Figure 2.12n
Infrastructure Design Review
- Turbine 14

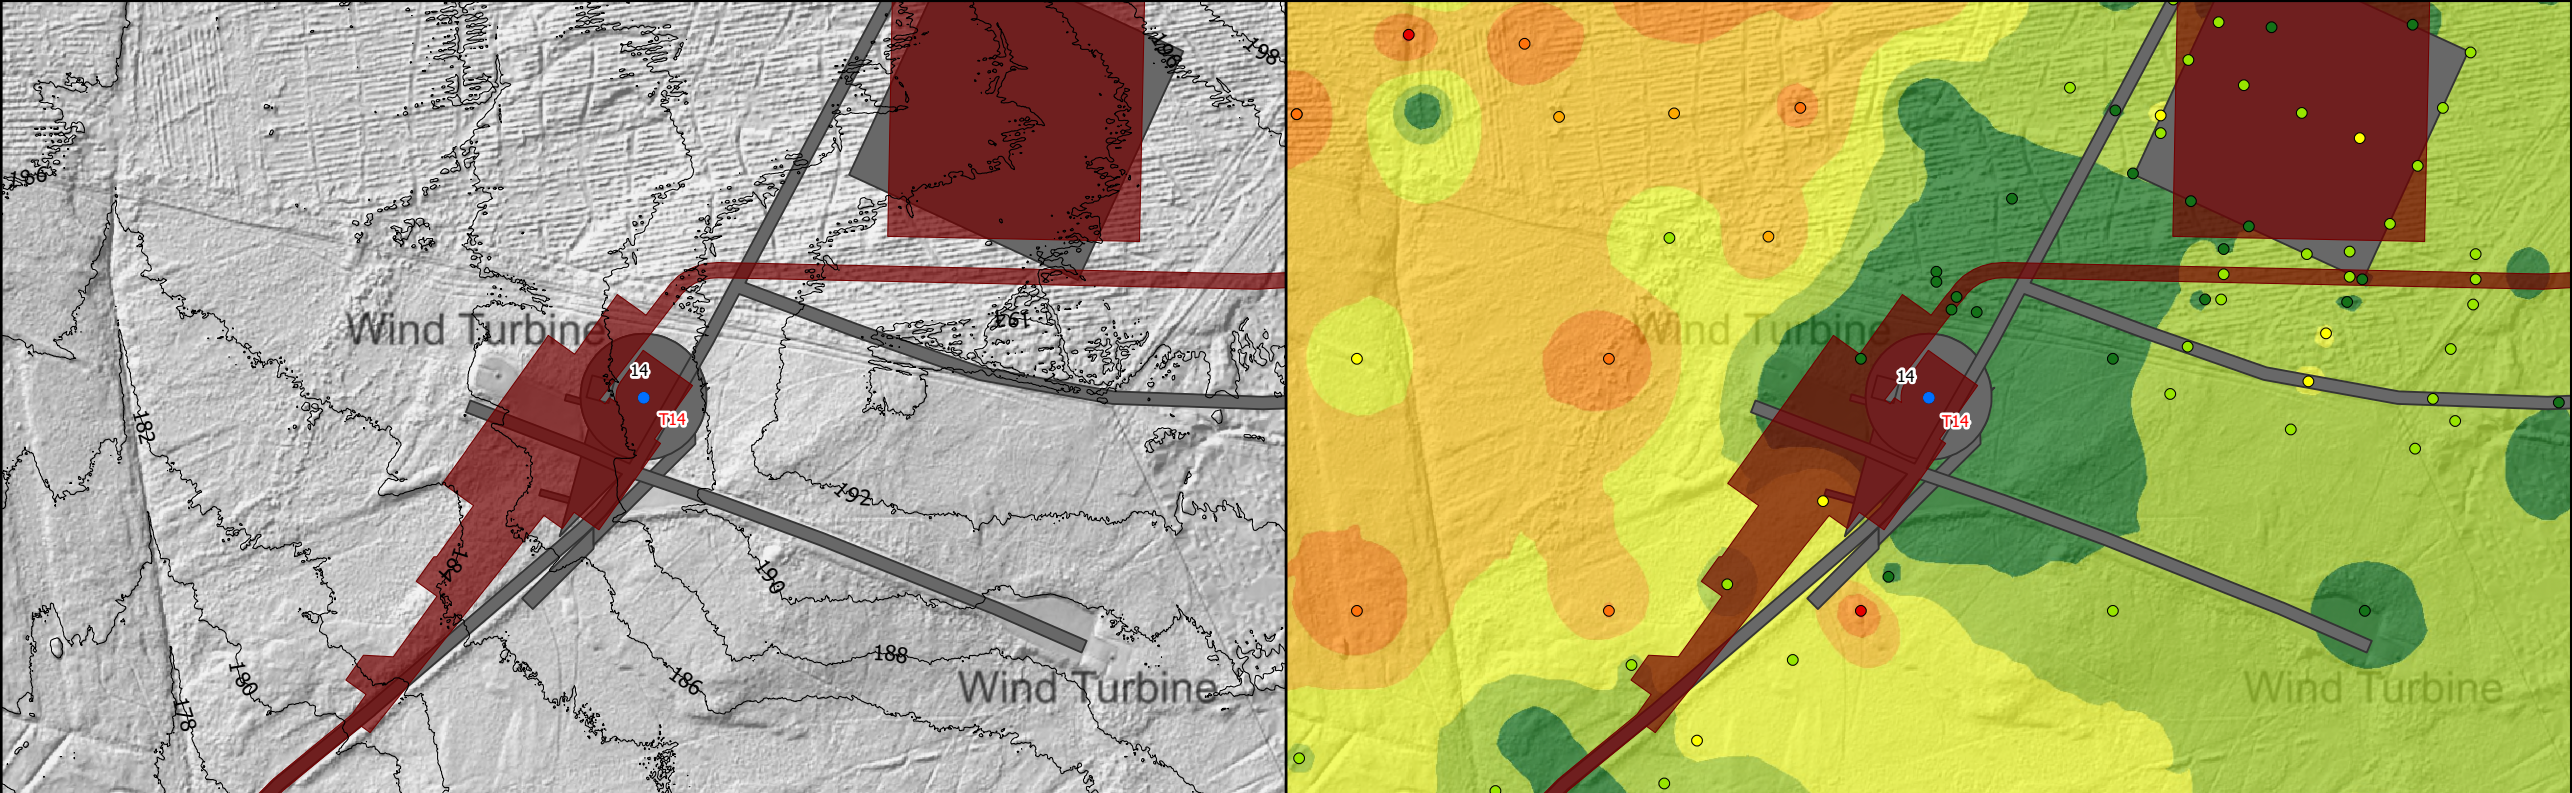
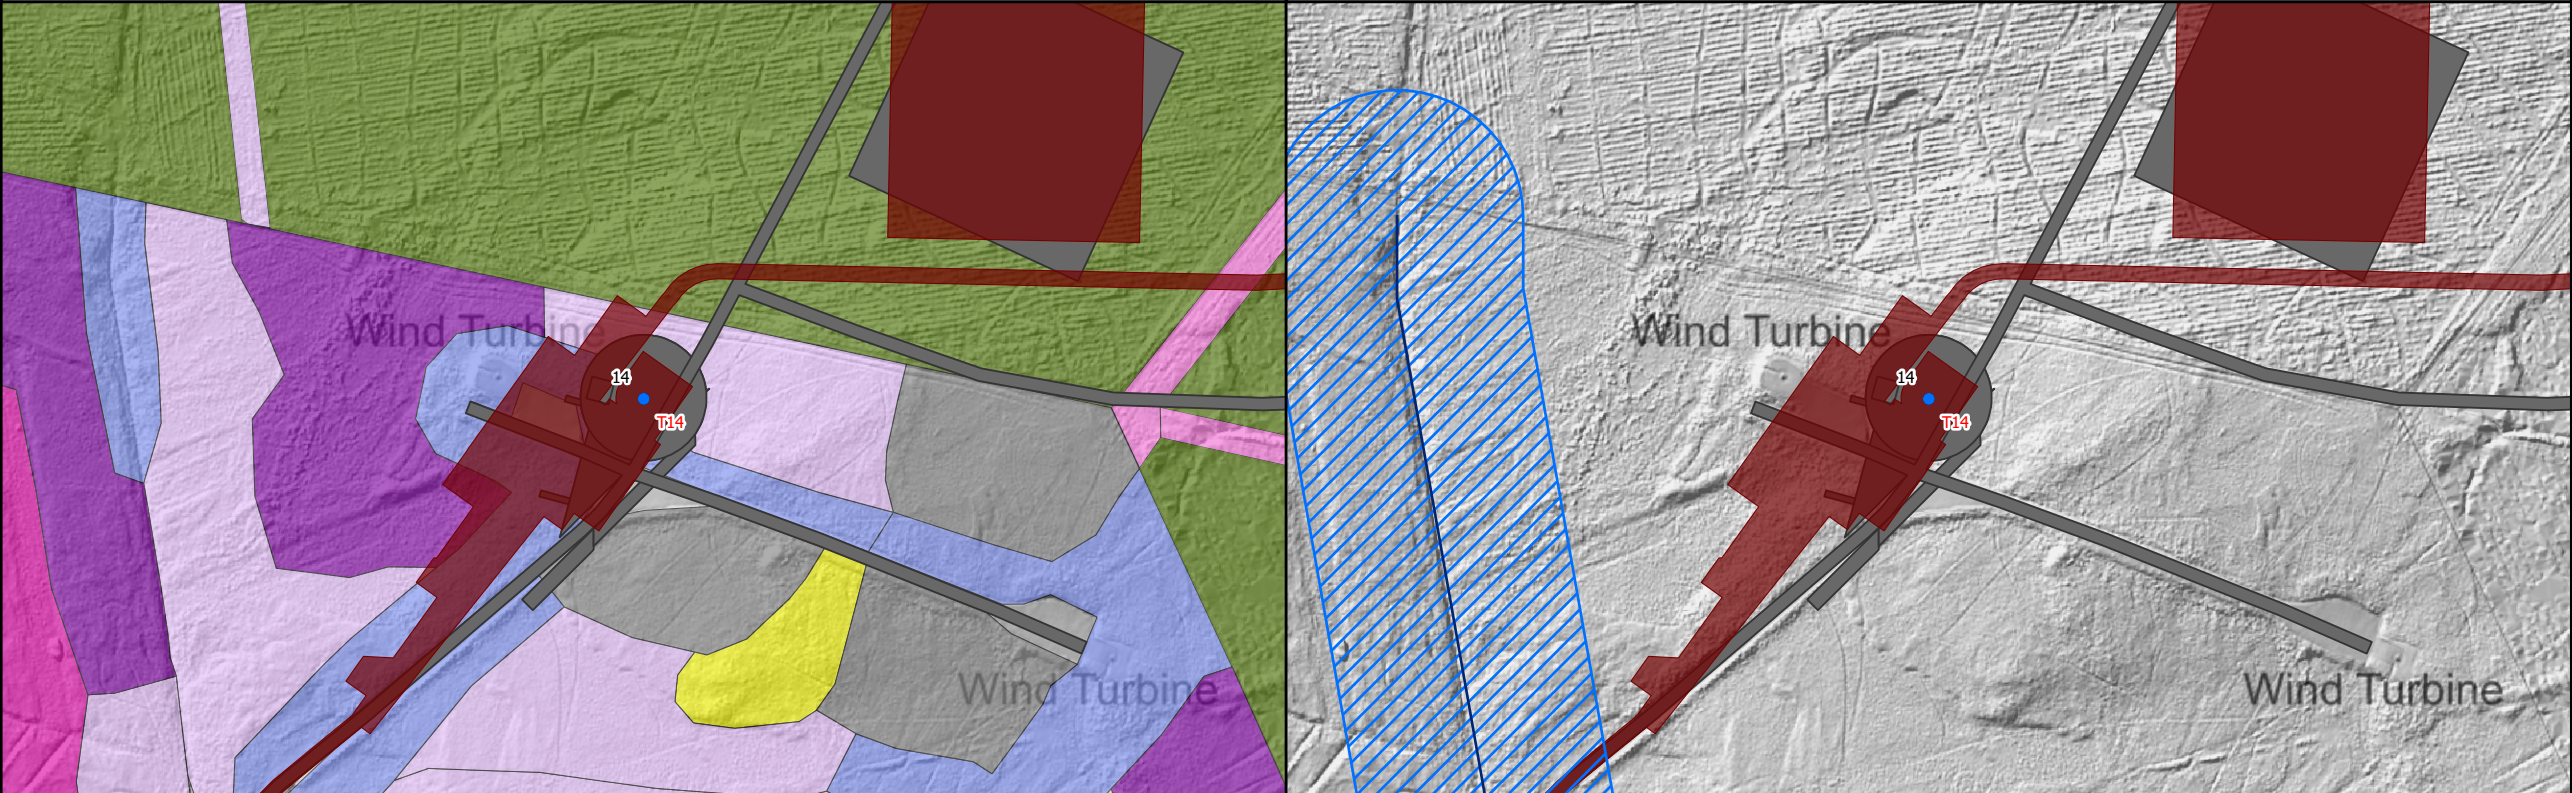
T14: Reason for Moving: This turbine location has not moved from the current consented location

Engineering: A length of track approximately 500m long has been removed from the consented layout. This track linked T14 with the turbines to the North.

Geology Impacts: The consented layout positions some of the infrastructure in a pocket of deep peat to the east of the track. The proposed layout has been developed to move away from this area of deep peat. The hardstand has been flipped along the line of the track. This requires the turbine deliveries to be modified which increases the offloading time, however the lesser peat impact was deemed to be a benefit to the site. The main portion of the hardstand will be located in shallow peat. The plan for turbine deliveries is to drive directly onto the hardstand and offload components. The unloaded vehicles will then use the turning head between T12 and T13 to turn and exit the site.

Ecology Impacts: The new location for the infrastructure sits within the same NVC areas as the consented development. The infrastructure will be located in Mire and Grassland.

Hydrology Impacts: There are no water buffers within the area adjacent to the turbine location.
